Office Action Summary

09/804,792

JINUPUN, PORAMASTE

DETAILED ACTION

(A) core with salient pole, each pole have teeth and windings.

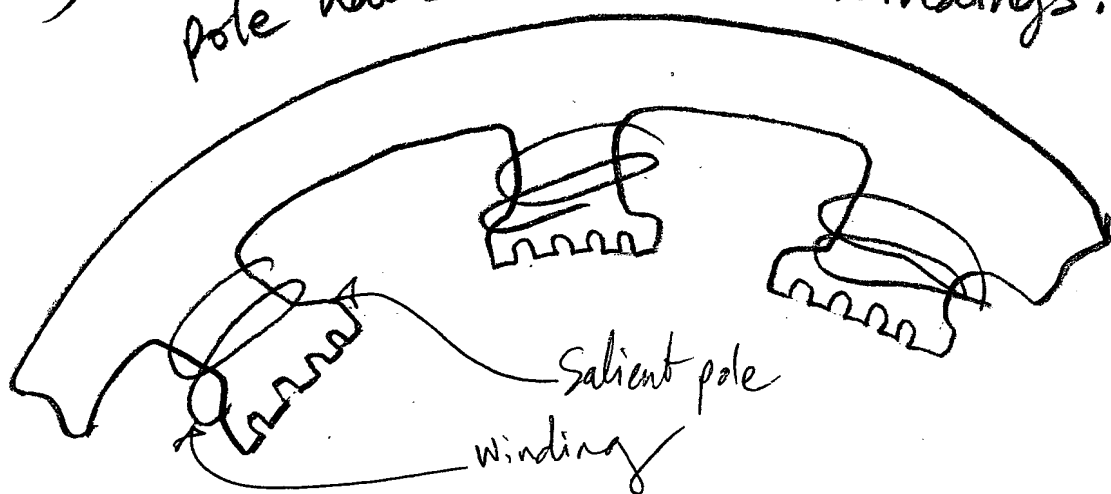
The drawings are objected to under 37 CFR 1.83(a). The drawings must show every feature of the invention specified in the claims. Therefore, *the salient poles of first assembly, wherein each pole subdivided into plural teeth, the windings wound one each or on alternate ones of respective teeth*, as in claim 1 lines 1-5 must be shown or the feature(s) canceled from the claim(s). No new matter should be entered. Note: Fig. 11d-22 show stator with plural poles, not each pole has plural teeth (see attachment).

The drawings of the claimed invention do not clearly distinguish whether the claimed invention is case (A) or (b).
